LICKING COUNTY LIBRARY
Parking Lot Improvements
ADDENDUM #1
February 25, 2019

ITEMIZED LIST OF CHANGES:

BOOK DROP @ MAIN LIBRARY

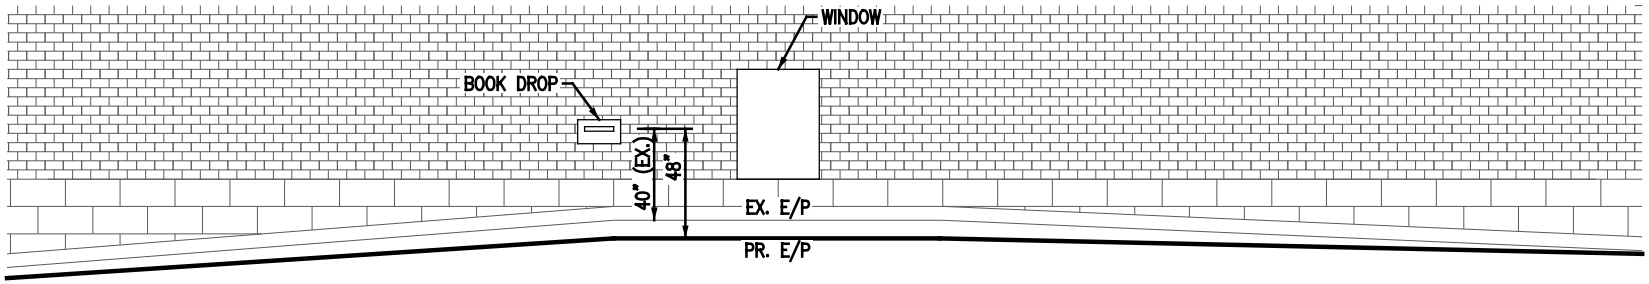
3. Detailed elevation view of the book drop pavement replacement has been attached to this addendum for clarity only.
4. Existing building foundation, to be removed as shown on sheet 3/7 has been added to the general summary (See Rev.1 on sheet 2/7)

SITE PLAN

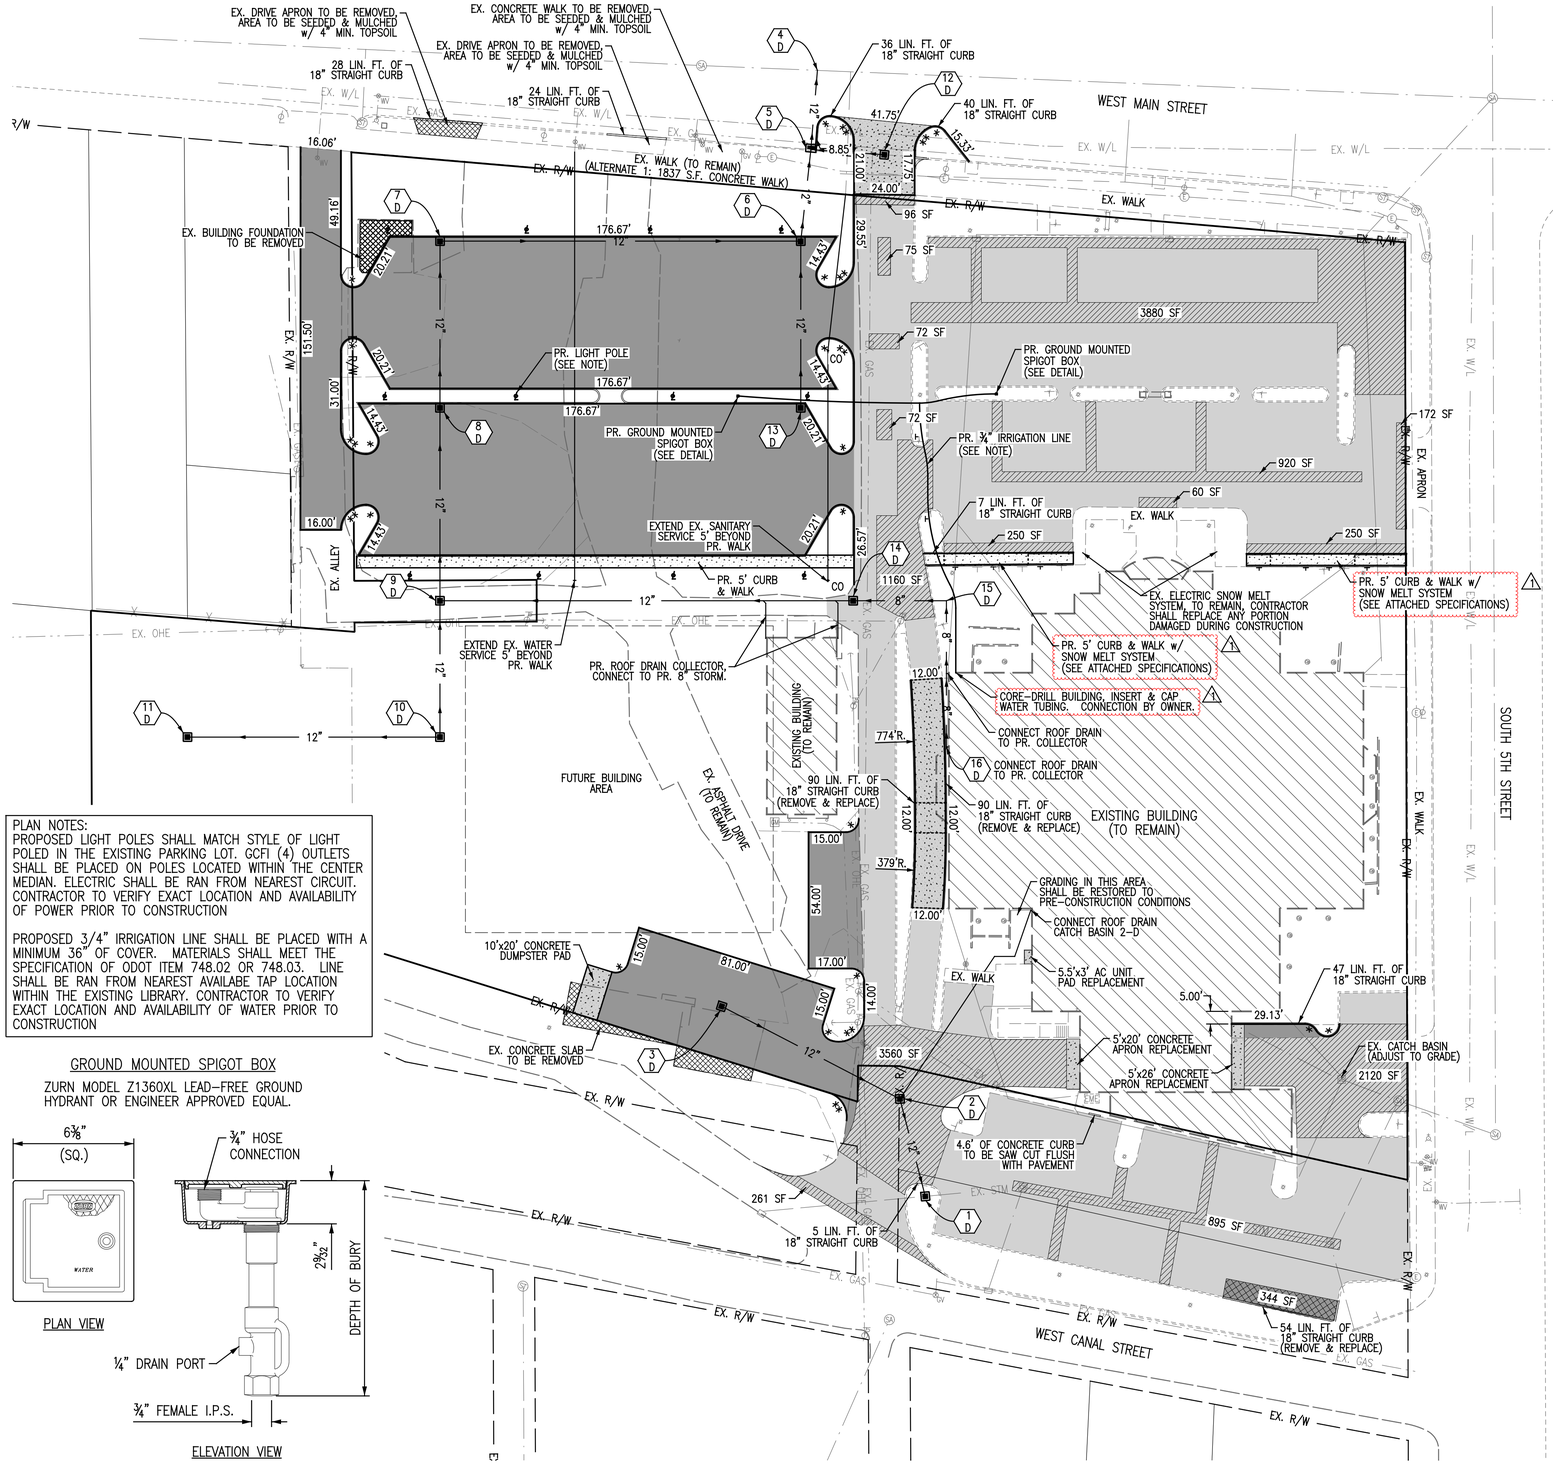
1. Snow melt system shall be added to the (2) sidewalk replacement sections (622 sq. ft. total) located in front of the existing library building (See Rev.1 on sheet 3/7). Electrical conduit shall be extended to the existing building, owner shall be responsible for electrical connecton to building. Snow melt system specifications have been attached to this addendum.

2. Water irrigation tubing shall be extended to the existing library as shown on the plan. Contractor shall core drill into building, extend water tubing into building, and cap proposed tubing. Location to be as directed by the owner, owner shall be responsible for water tubing connection to existing building plumbing. (See Rev.1 on sheet 3/7).

5. Item 407 Tack Coat (0.075 Gal./Sq. Yd.) has been added between existing pavement and proposed pavement layers, and between all proposed pavement layers. (See Rev.1 on sheet 3/7)

1. Item 448 1 1/2" Asphalt Concrete, Surface Course, Type 1
2. Item 448 2 1/2" Asphalt Concrete, Intermediate Course, Type 2 ⚠1
3. Item 207 Tack Coat (@0.075 Gal/Sq. Yd.)
4. Item 608 4" Concrete Walk (Class C Concrete)
5. Item 452 6" Non-Reinforced P.C. Concrete Pavement, Class C
6. Item 304 4" Aggregate Base
7. Item 304 6" Aggregate Base
8. Item 254 Pavement Planing (1 1/2" Typ.)
9. Item 204 Subgrade Compaction
10. Item 609 18" Straight Curb
- EX Existing Pavement Section (To Remain)

ALL COSTS SHALL BE INCLUDED WITH ITEM 253 – PAVEMENT REPAIR, AS PER PLAN. ⚠1
